11 July 2022

Planning Permit Application TP 136/2021

Proposed Use and Development of a Place of Assembly, Outbuilding, Display of Signage, and Development of Land

Lot 1, TP164431R Mount Baimbridge Road, Hamilton 3300

Drawing No.
PROPOSED SHED PLAN & ELEVATIONS

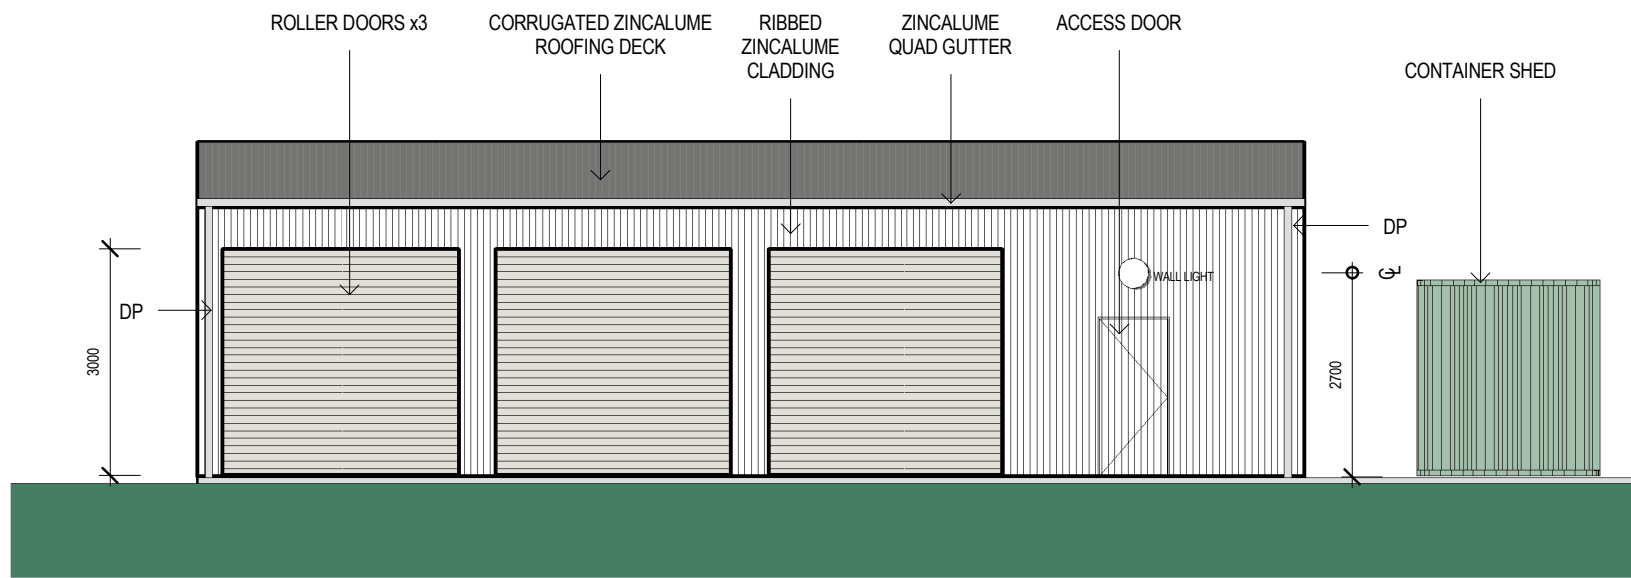
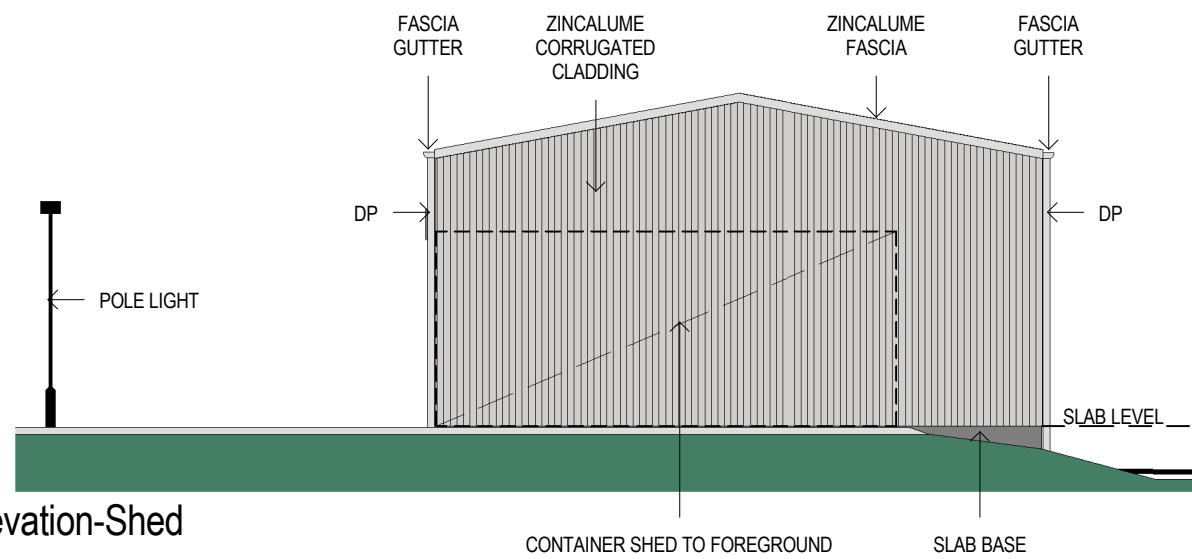
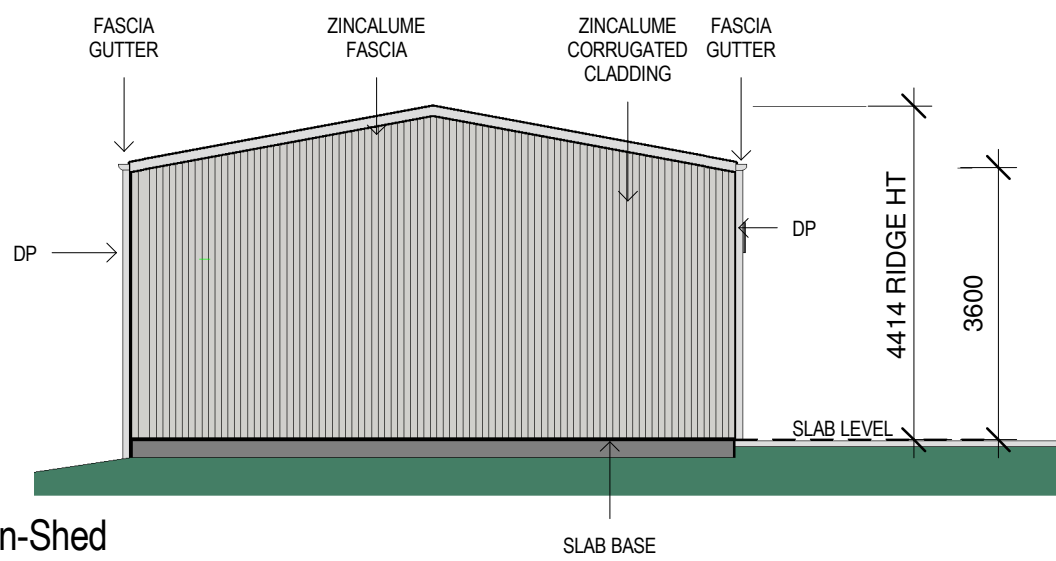
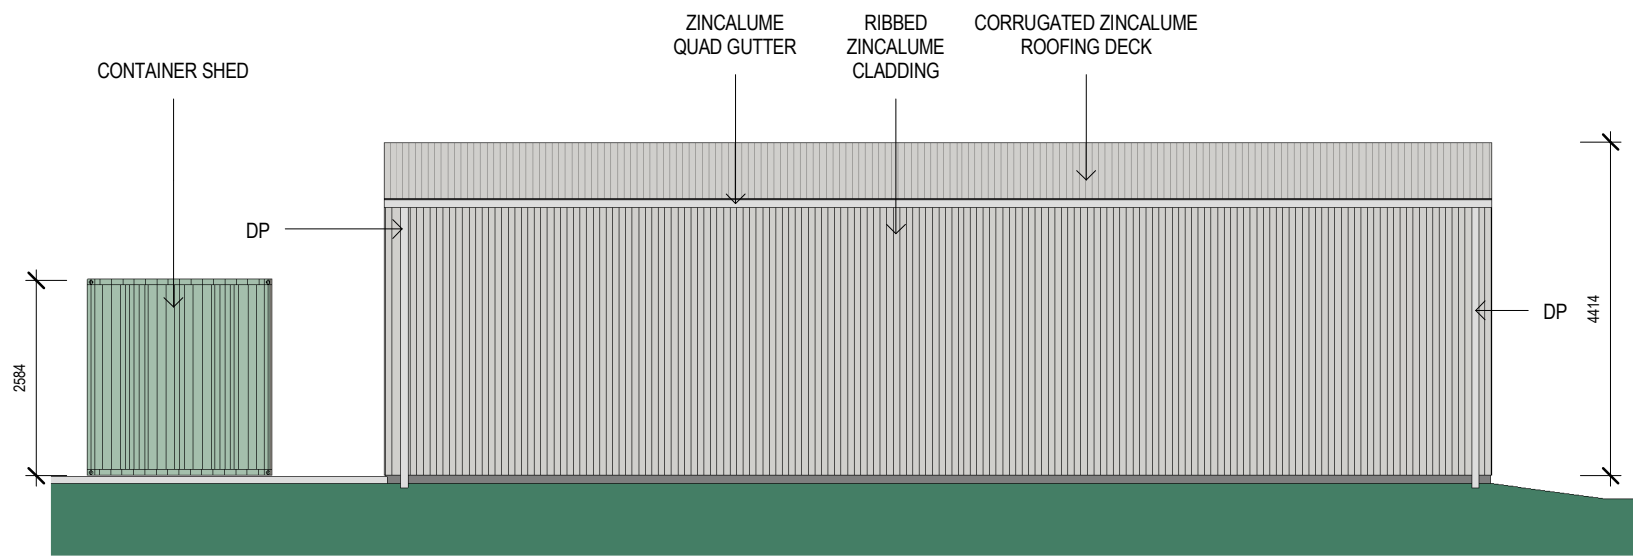
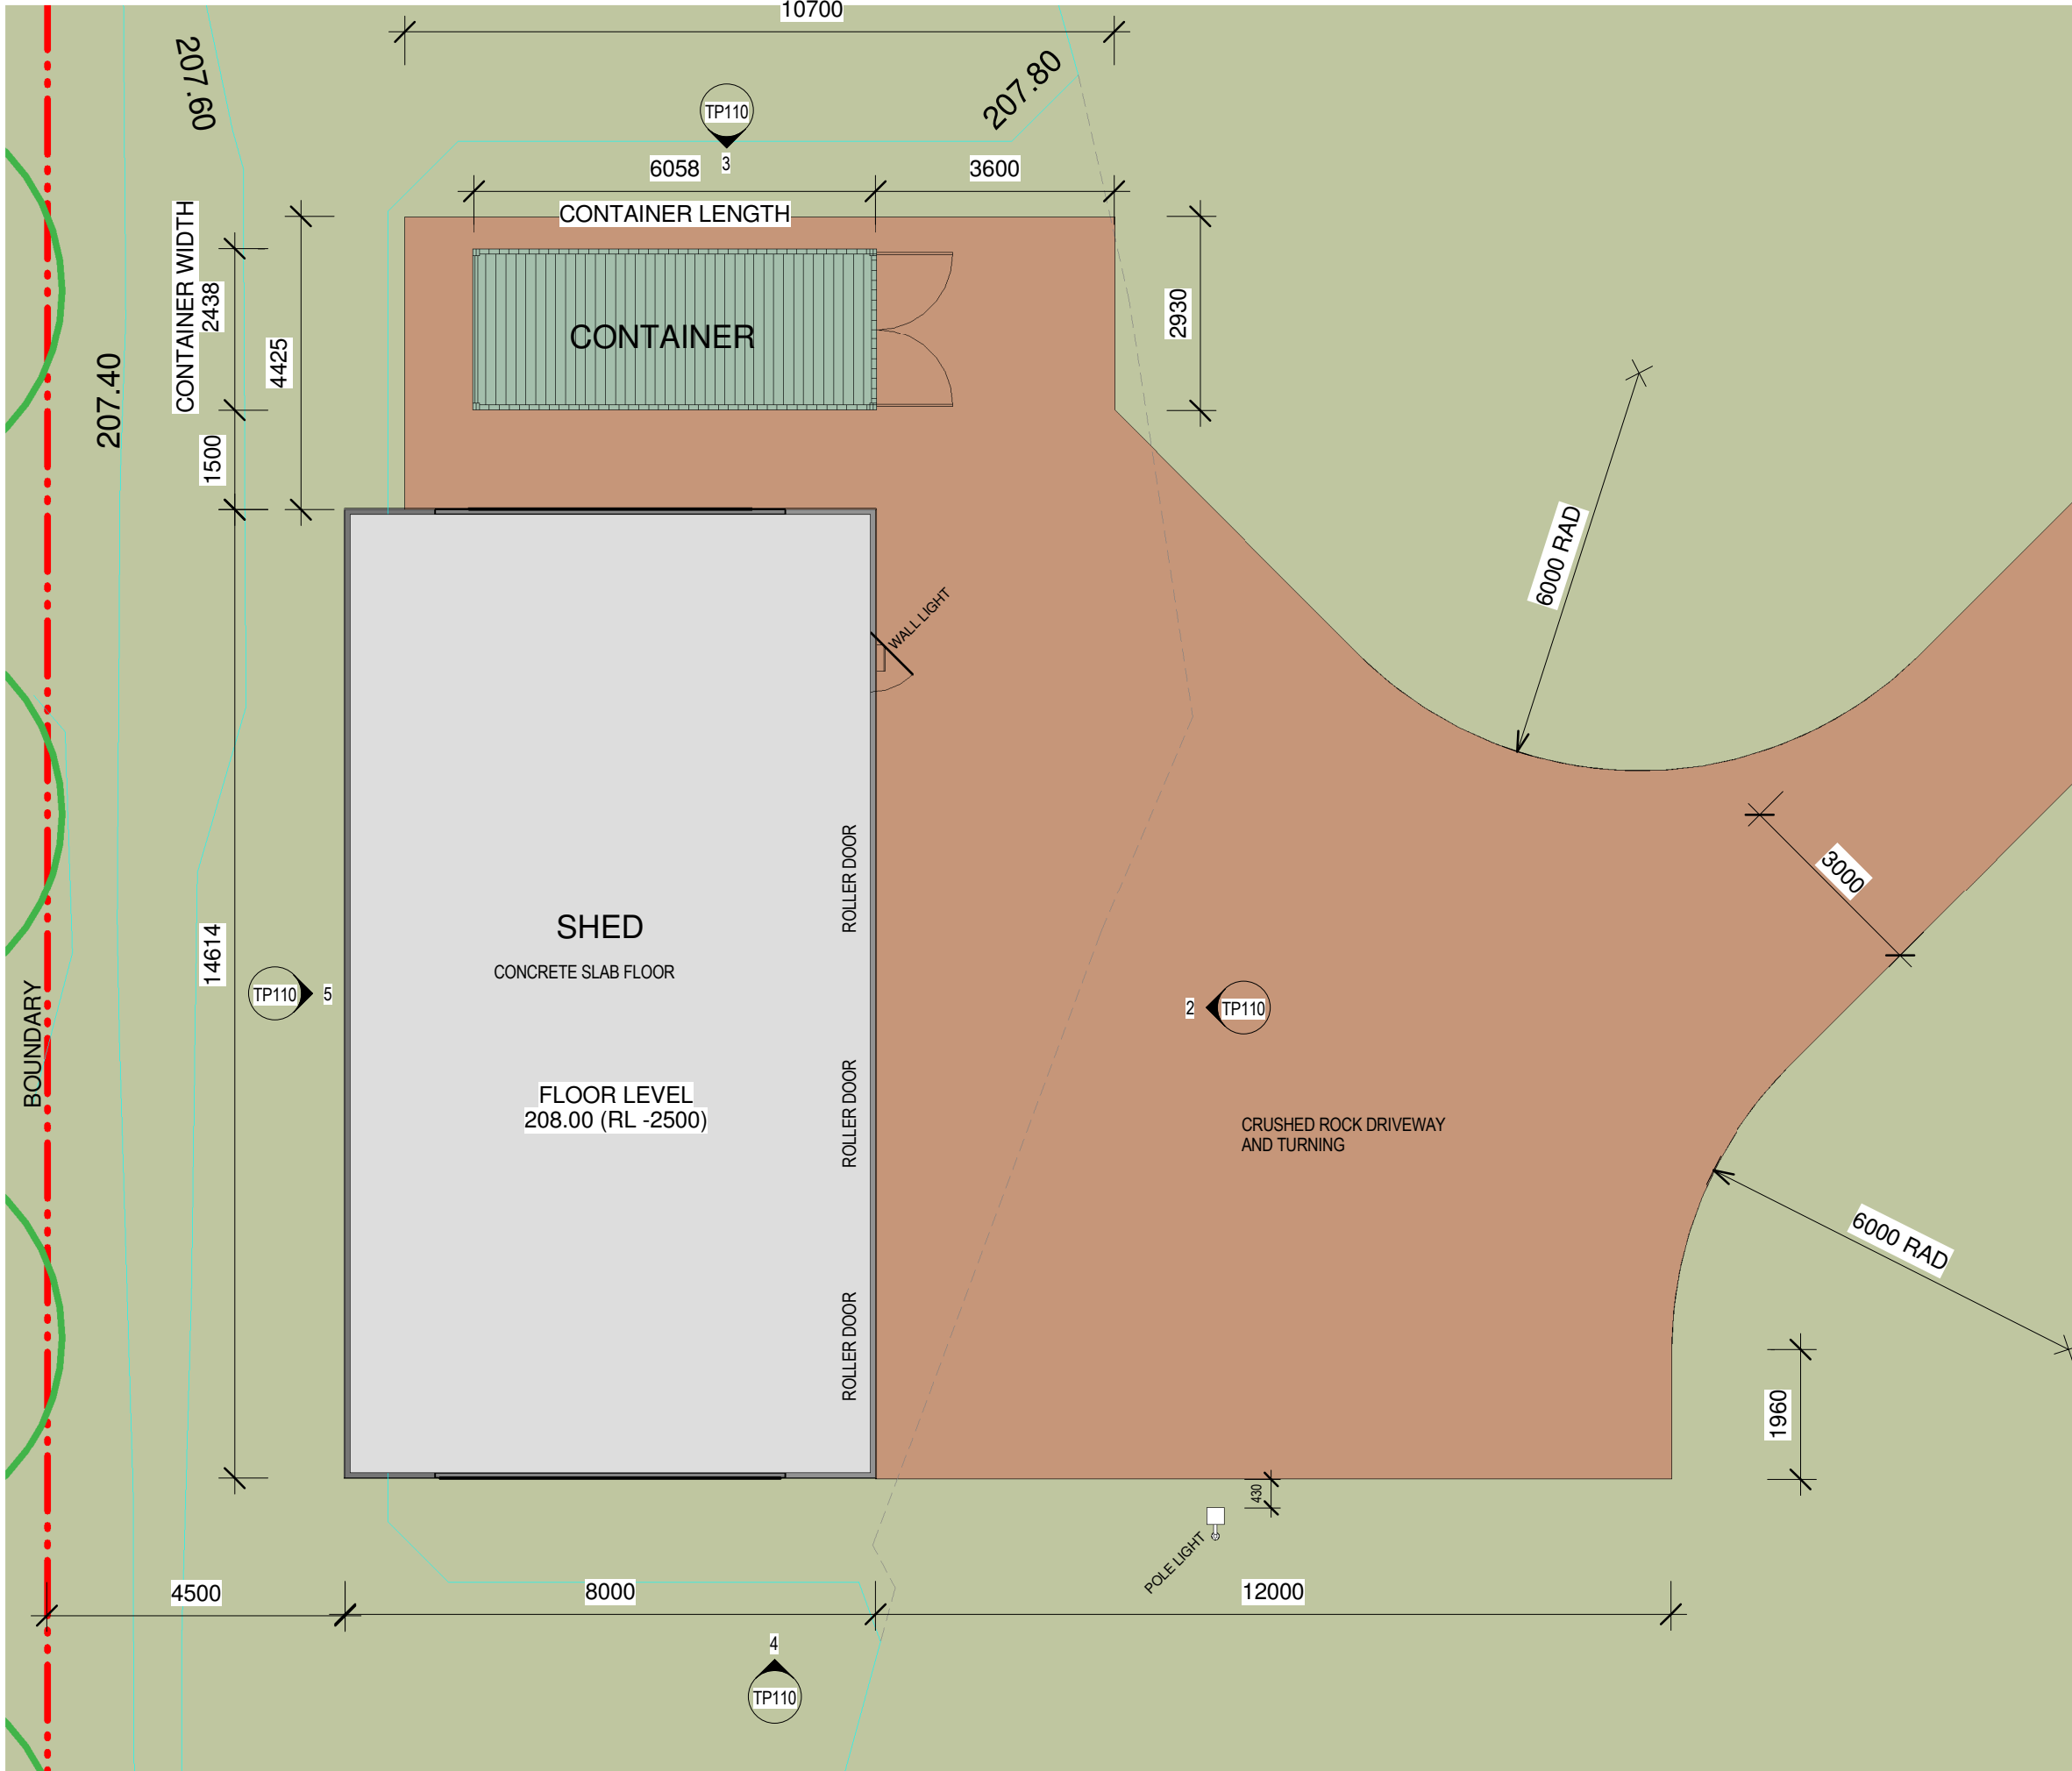
7. Amended Elevation Plan that show the orientation north south east west (as opposed to Shed E etc) of the proposed shed and shipping container.

7 Refer to the amended Shed & Container Plan and Elevations.
